Ash River – ProtoDUNE II Trial Assembly Tests – Inverted APA

William Miller
Tom Wieber
Charles Cadeau
University of Minnesota
29 June 2021

Summary of Documents-Load Tests

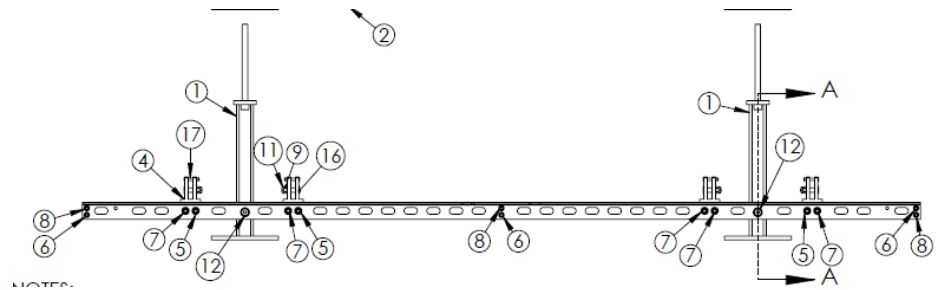
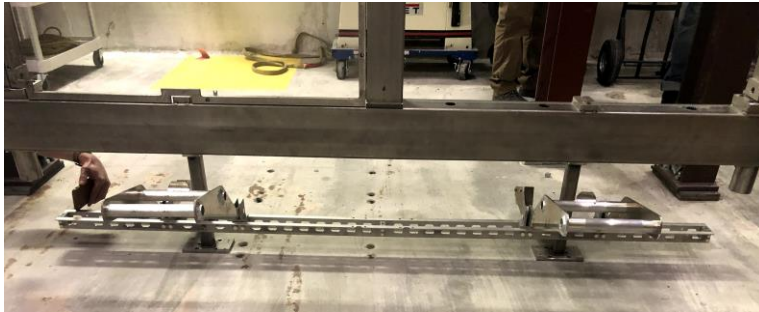
- We developed alignment issues related to block pulleys, they could not be rotated to 180° so that cable tracked properly
 - Switching to web version of winch to minimize issues with stiffer ¼” cable

- Working on revised design

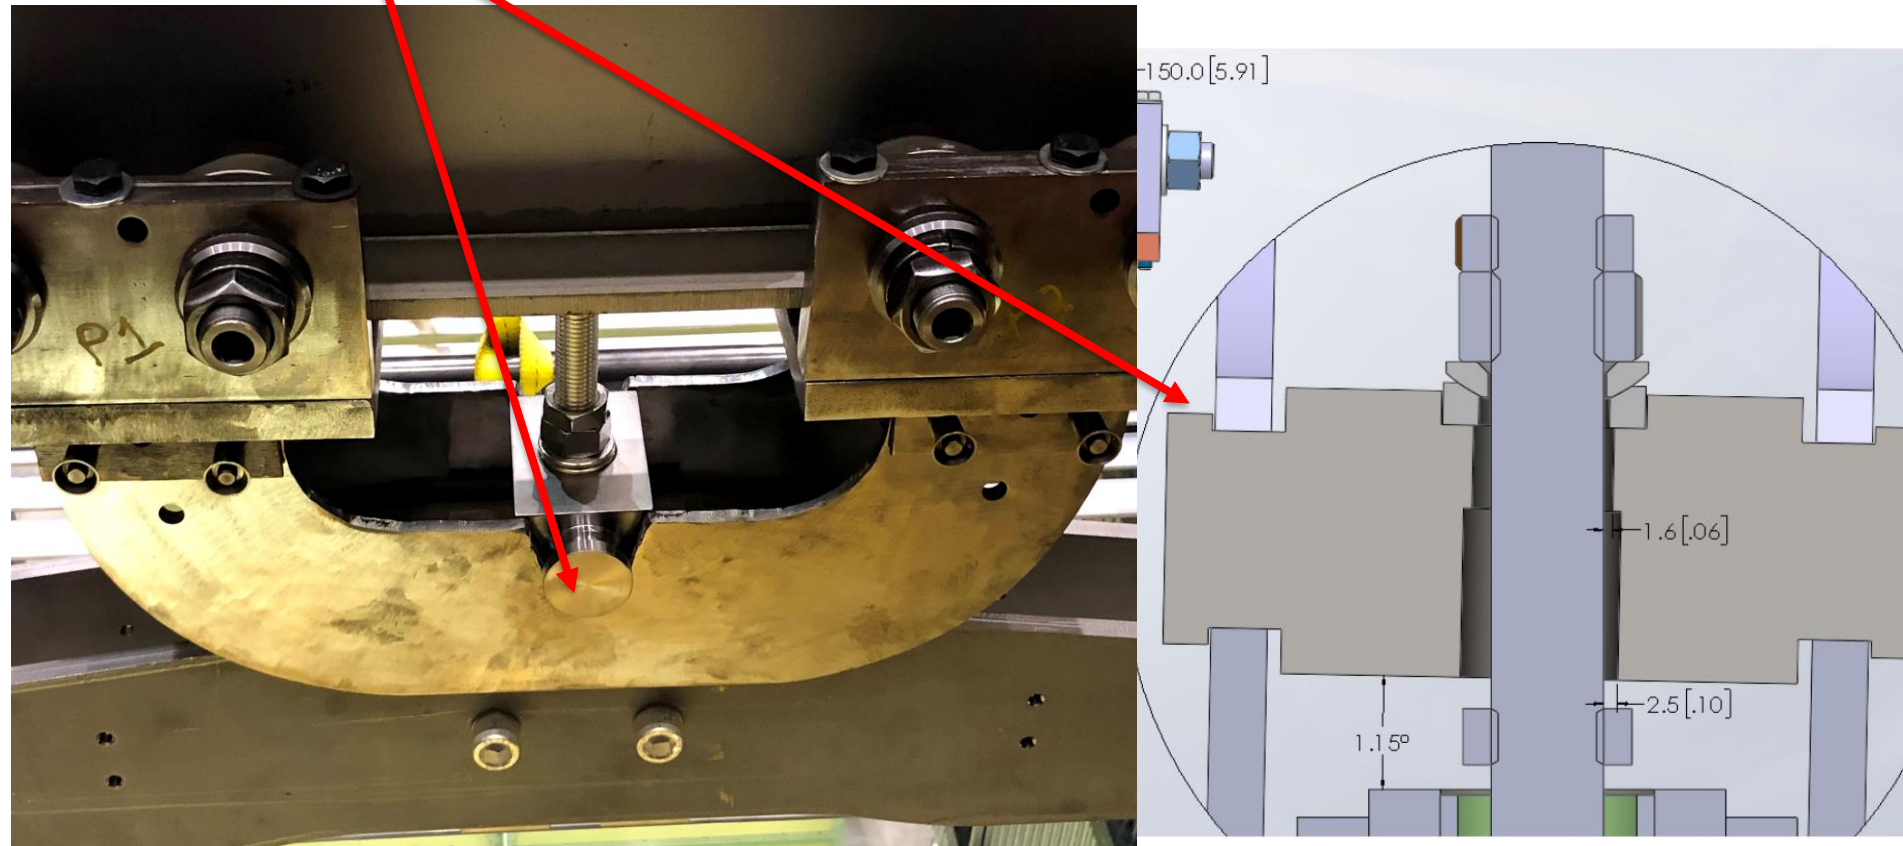
APA Adapter connection: Increase the diameter of the outer retention ring feature of the adapter to minimize possibility of not securely engaging

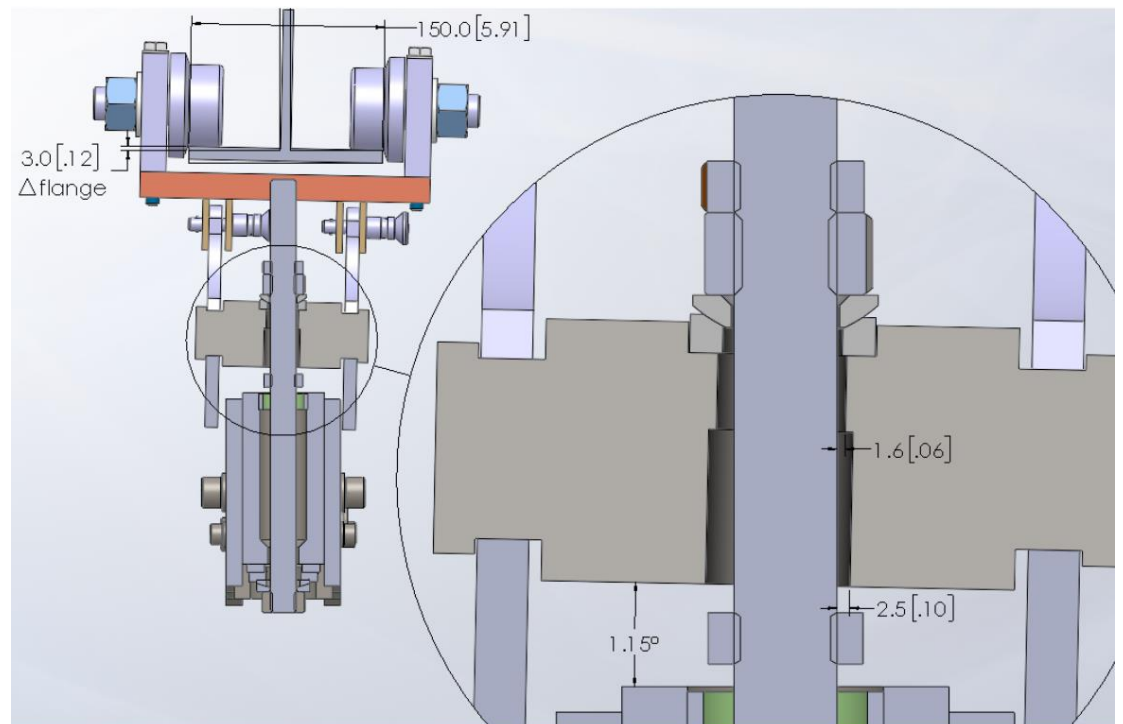
APA Adapter: The ProtoDUNE II stainless steel beams are twisted enough that the spherical washers were certainly needed

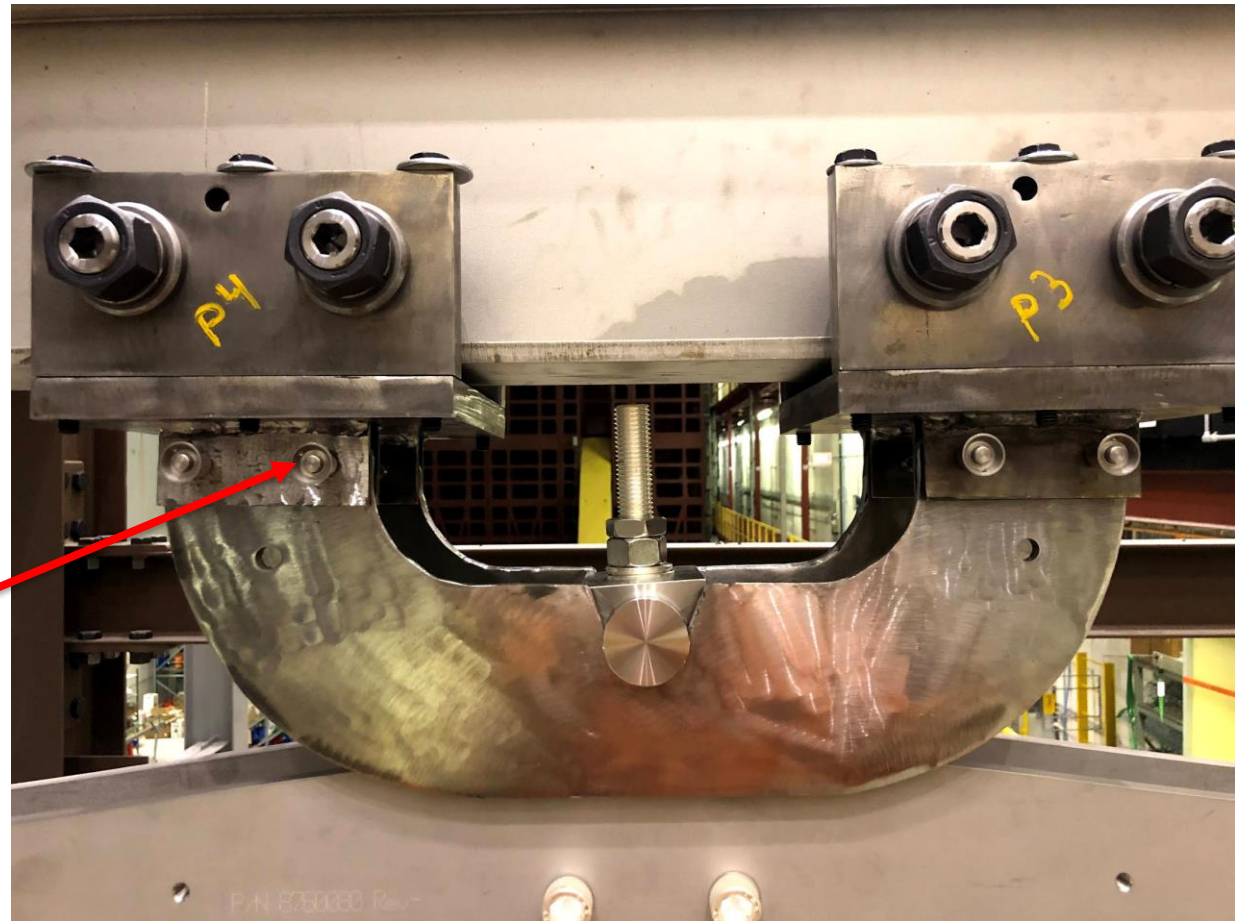
Load tests on APA Trolley: some of the quick disconnect pins have no load on them, In some cases only 4 out of the 8 were loaded

Loose pin
that could
be rotated
on Top APA

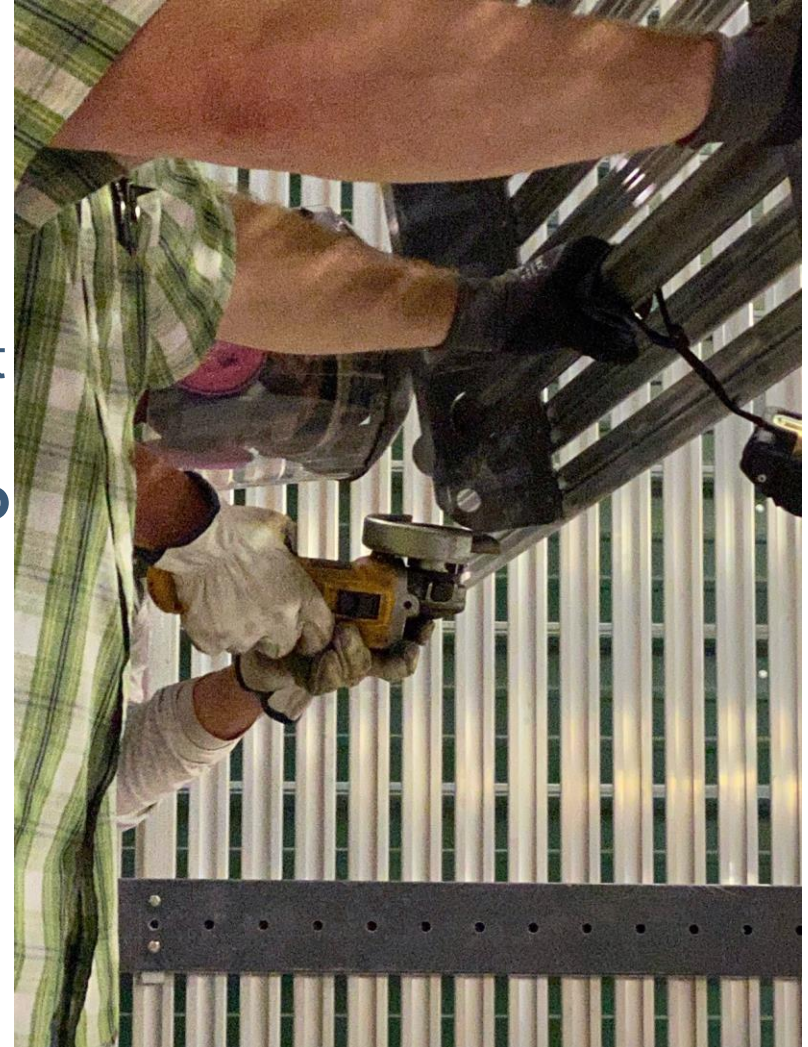
- FC did not have rounded edges on pivoting end, it was fixed on drawings but not on supplied parts, also missing reinforcement plates. Do they need to put back on? **Verify drawings of FC, also check for reinforcement plates**
- Could not hand walk bottom FC into position, need to install on CPA in cleanroom installation sequence

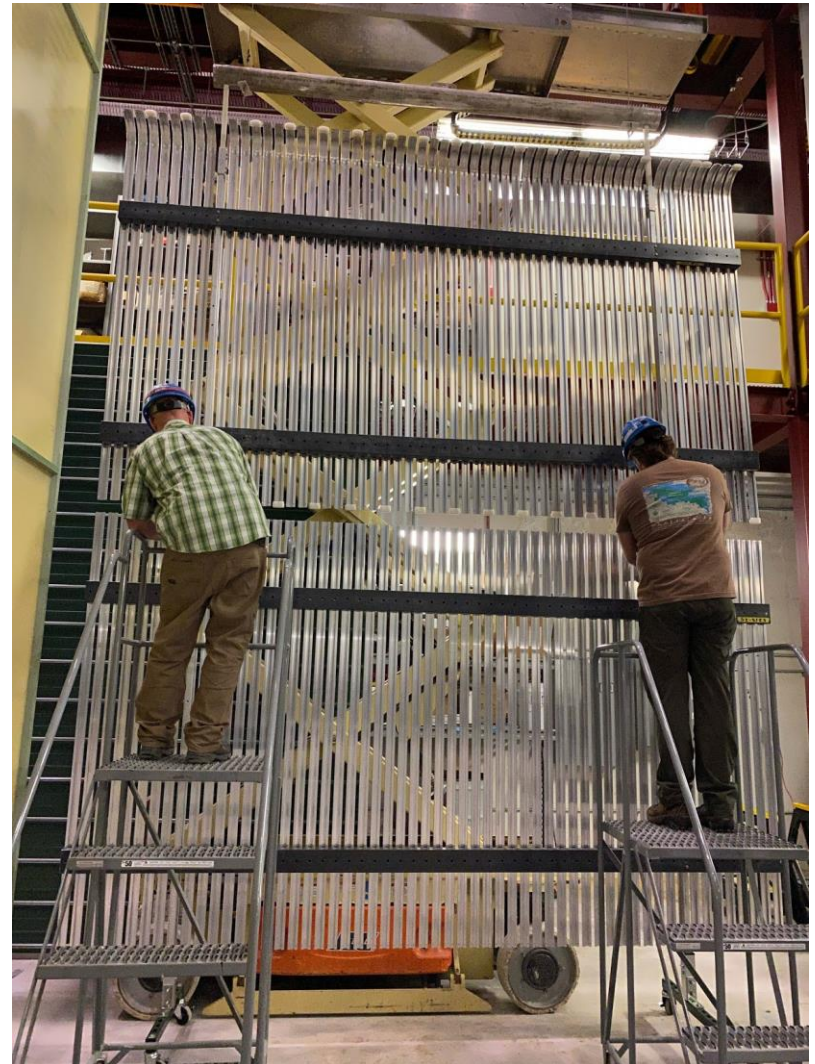
End Wall Installation: There is not enough clearance if both end walls are side by side during installation. This is just fine since for ProtoDUNE II we can raise the Endwalls one at a time and roll them into position.

We will have to make the installation procedures for Row 1 in DUNE the same so that we can slide them into position.
